Catawba Nuclear Station, Units 1 and 2
Docket Nos. 50-413 and 50-414

License Amendment Request Revising Catawba, Units 1
and 2 Commitments to USNRC Regulatory Guide 1.82,
Revision 0, "Sumps For Emergency Core Cooling and
Containment Spray Systems" and Revising Technical
Specification Surveillance Requirement (SR) 3.5.2.8
and Associated Bases.

ATTACHMENT 3
Evaluation for License Amendment Request

Figure 1: Current ECCS Sump Design Drawing

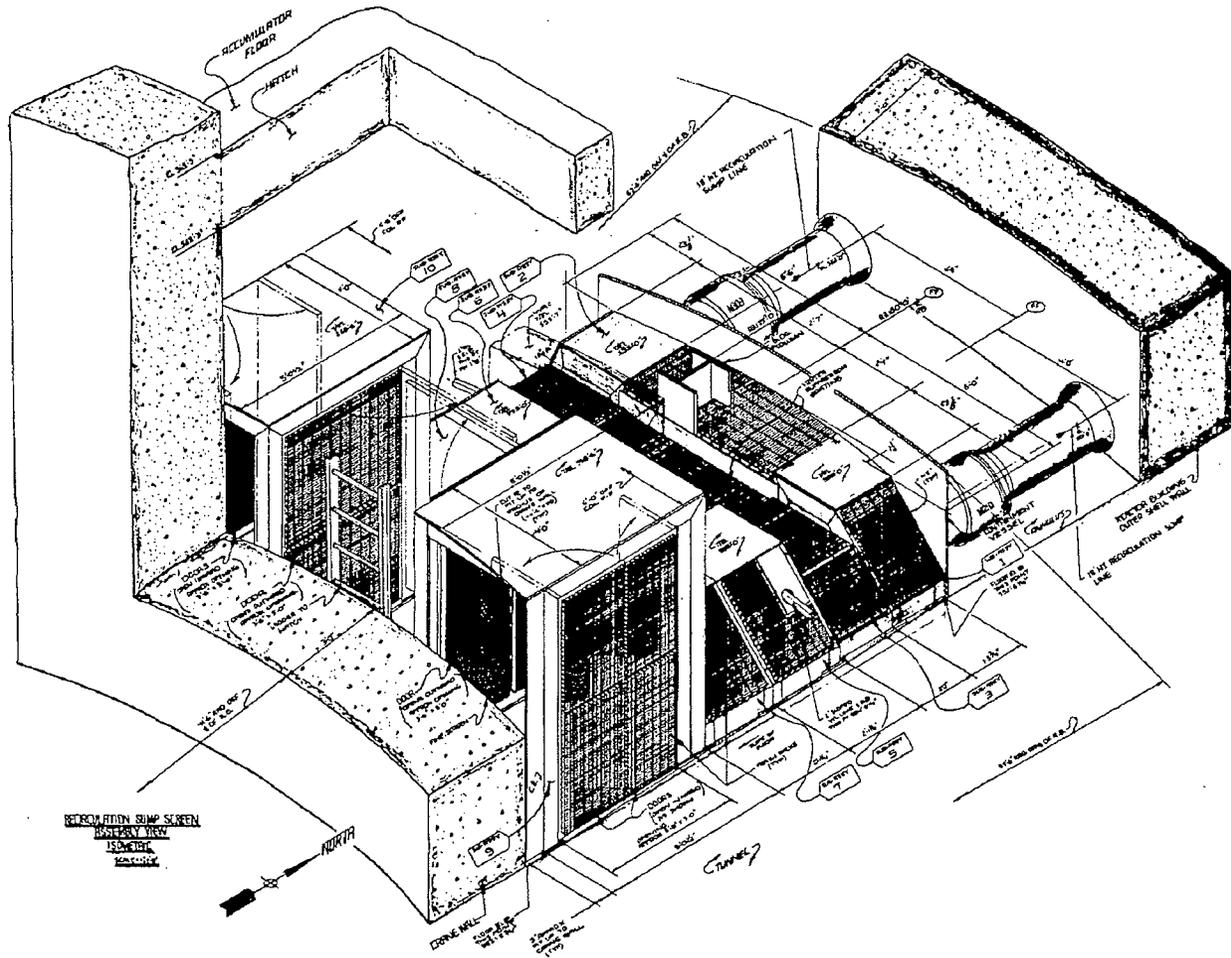
Each "sump" screen assembly consists of a horizontal solid top and filtering screen panels which extend almost to the floor. Above the ECCS intake pipe, the horizontal solid top of the screen assembly is at approximately 555' elevation. Beyond the ECCS intake pipe, the horizontal solid top extends slightly higher to approximately 558' elevation. The screen panels contain an outer trash rack which prevents large debris from reaching the inner fine screen. The fine screen prevents particles which are large enough to

impair ECCS or containment spray performance from being drawn into these systems. The fine screen mesh is sized to preclude any particle larger than 1/8" in diameter. This size is significantly smaller than the size needed to prevent clogging of the NS spray nozzles. The top of the screen assembly contains holes which are 1/8" in diameter. This feature ensures that the assemblies are self venting as the water covers the top. Sump Recirculation Screen performance, including the description of debris transport through the Containment, is discussed and evaluated in the Catawba UFSAR Section 6.2.2.2. A summary drawing of this structure also appears in the UFSAR, Figure 6-111. Reference Figure 1.

Figure 2: Modified ECCS Sump Design Drawings and Photo

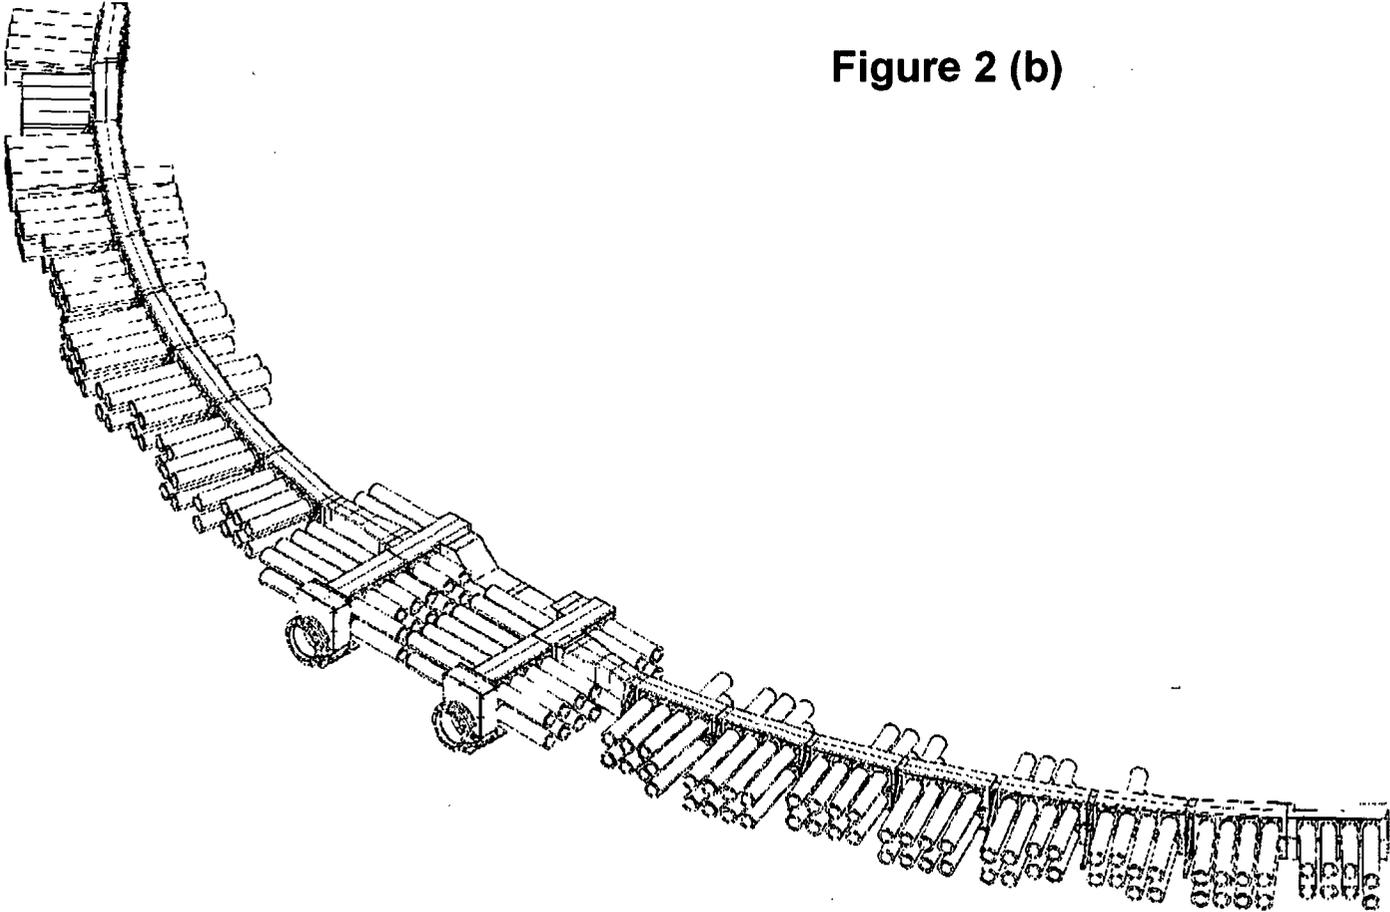
The Catawba modification removes the original ECCS Sump structure described above and replaces it with a structure consisting of tube modules (top-hats) made of stainless steel, having two layers of perforated plate for straining debris from the water. (Reference Figure 2.) The openings in the perforated plate do not exceed 3/32 inch diameter. The RHR/CSS recirculation lines are connected to the main plenum of the strainer assembly using 18 inch piping. Horizontal vortex suppressors will be installed above the top-hat strainer assemblies.

The Catawba strainer will be installed entirely inside the pipechase outside the polar crane wall. There are no pipe whips or water/steam jet loads projected to occur within the Catawba pipechase.

the RHR/CSS Pumps during the post-LOCA Recirculation Phase. The new strainer offers approximately 2000 square feet of surface area versus the original 135 square feet total for the original sump screens. When completed, the installation of the revised sump design is intended to resolve concerns associated with GSI-191. The changes made enhance the existing design by providing a larger surface area for the filtration of debris.
